CITY OF ALBUQUERQUE

RE: **Lot 1 Block 5 Unit 18
6601 Papagayo NW
Volcano Cliffs Subdivision
Grading and Drainage Plan
Engineers Stamp Date 10/7/2025 (D10D003K1)**

Grading Plan

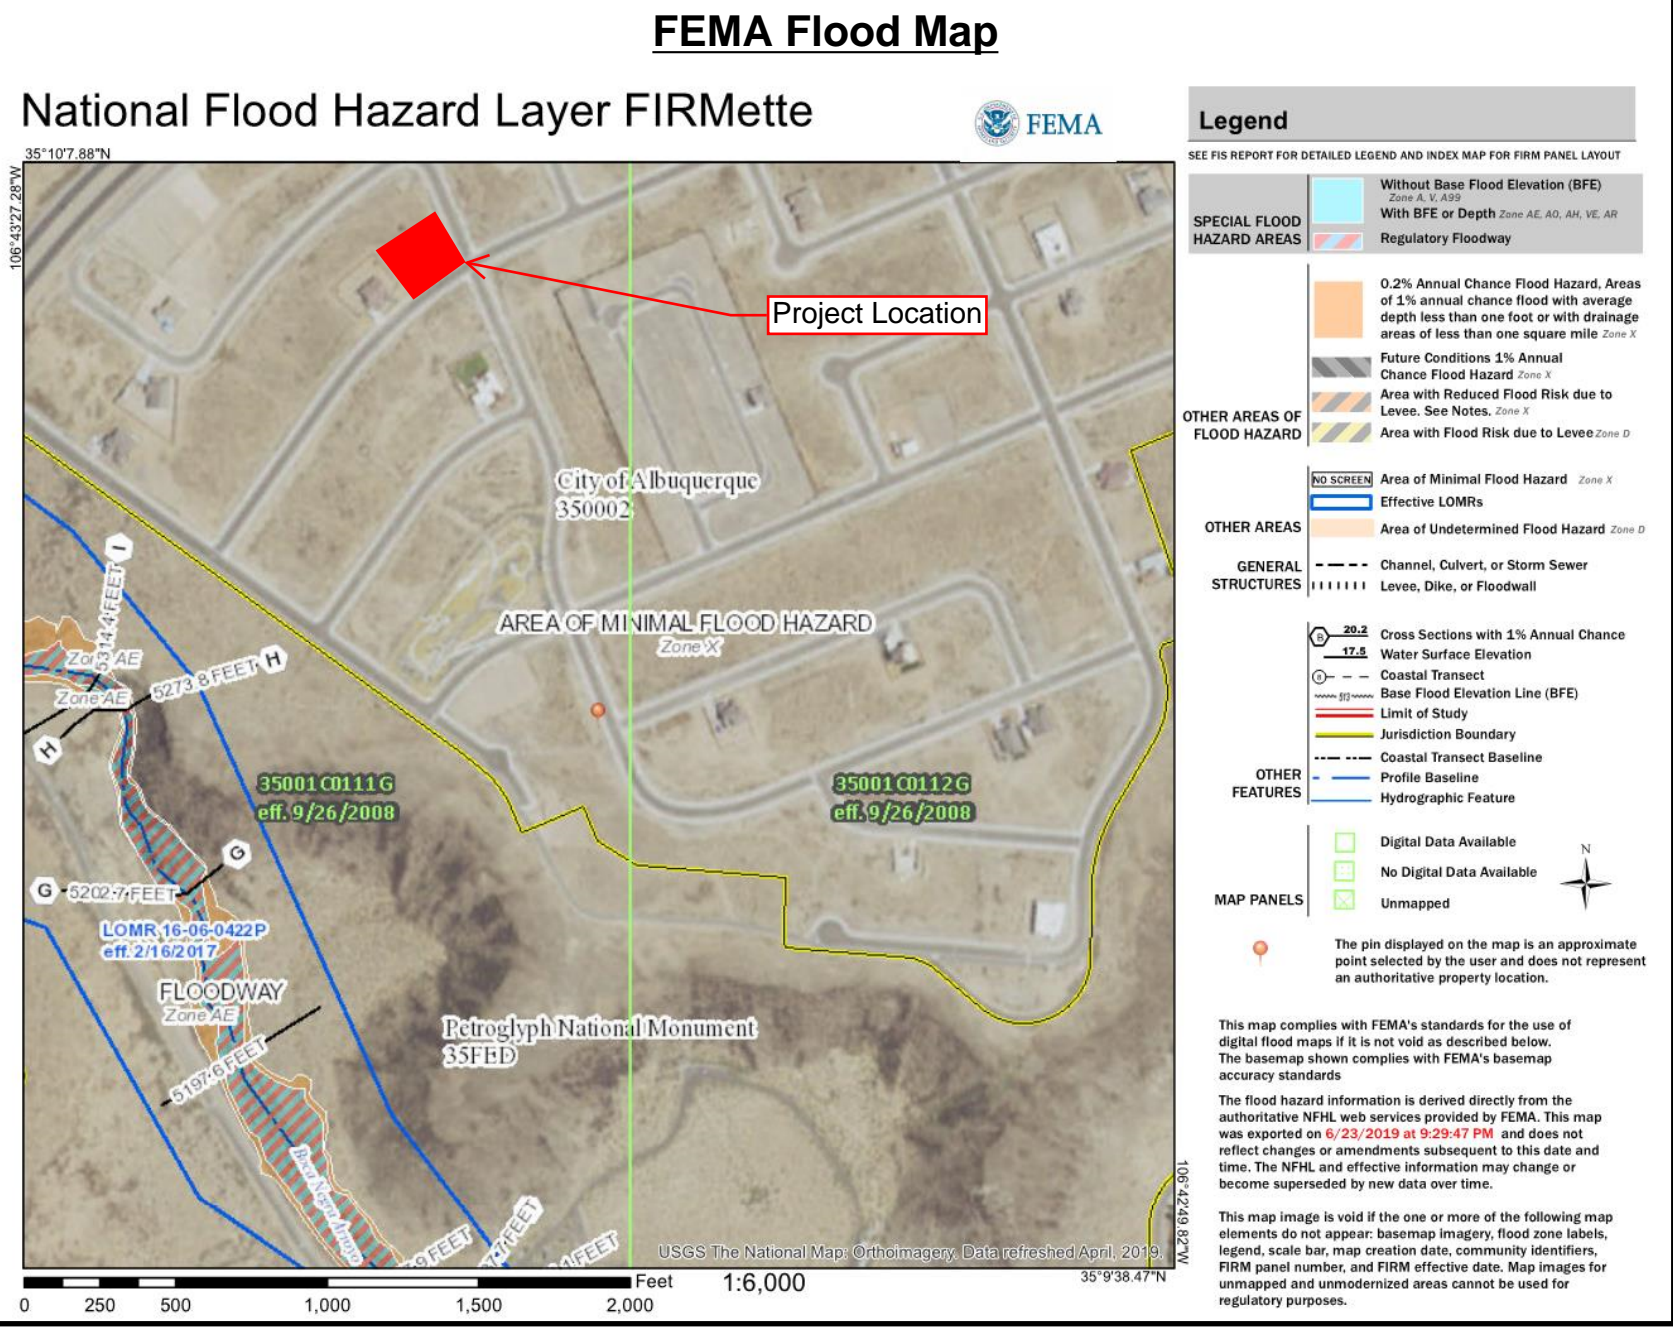
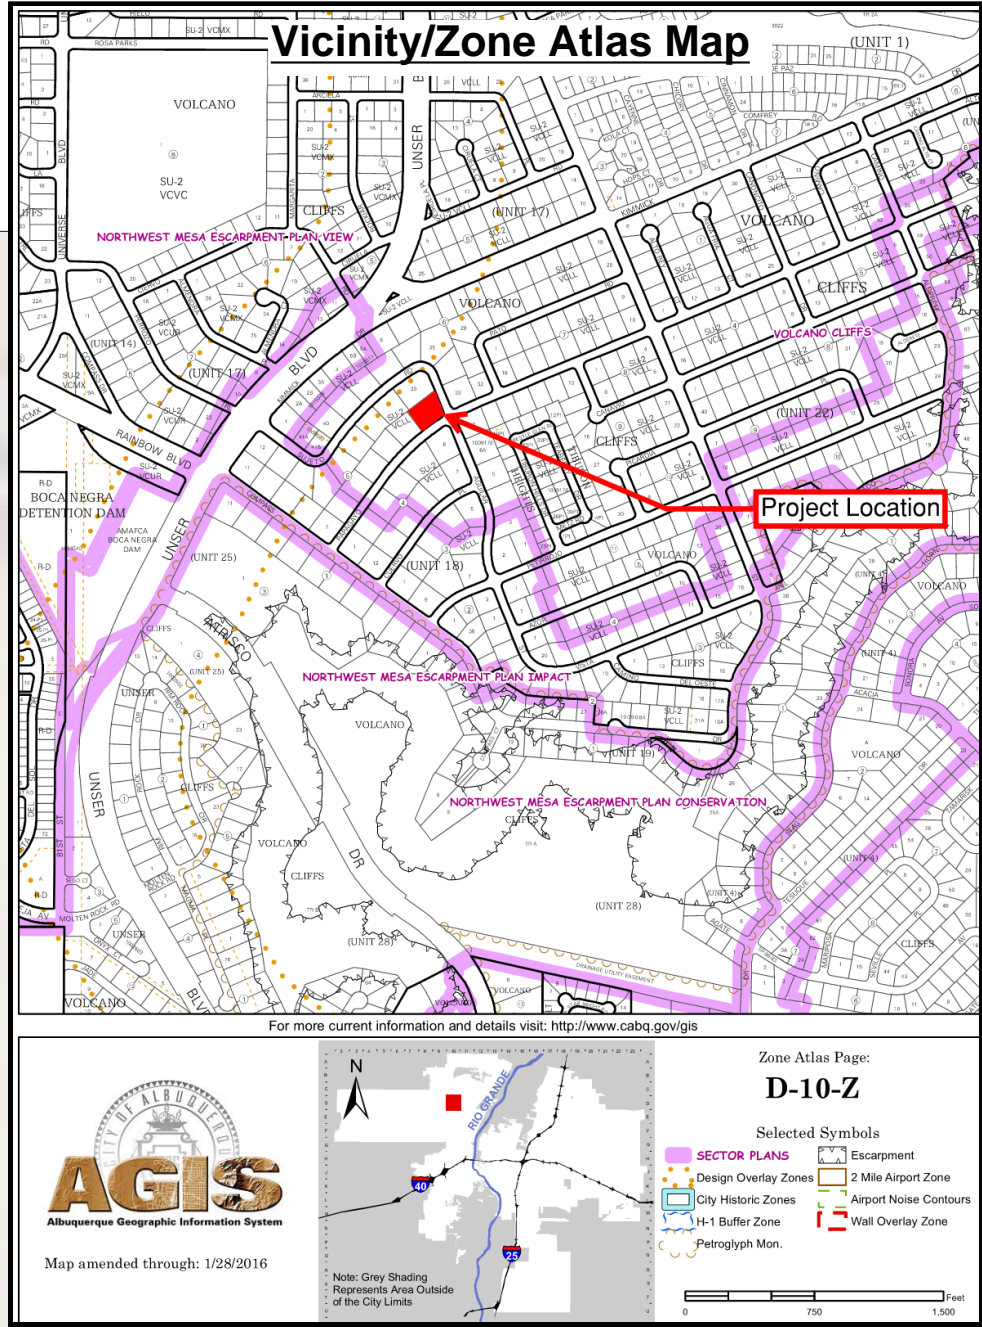
Advise the owner contractor not to use dirt as a ramp to climb the curb, use lumber or crusher fines for this purpose. Place this note on the plan.

Reiterate to the Owner/Contractor that a separate permit for a garden/retaining wall must be obtained with the approved G&D plan and Pad Certification. Also, if a swimming pool is to be placed after this approval a new grading and drainage plan will need to be resubmitted showing the changes for the land treatments.

Prior to Certificate of Occupancy release, Engineer Certification per the DPM checklist is required.
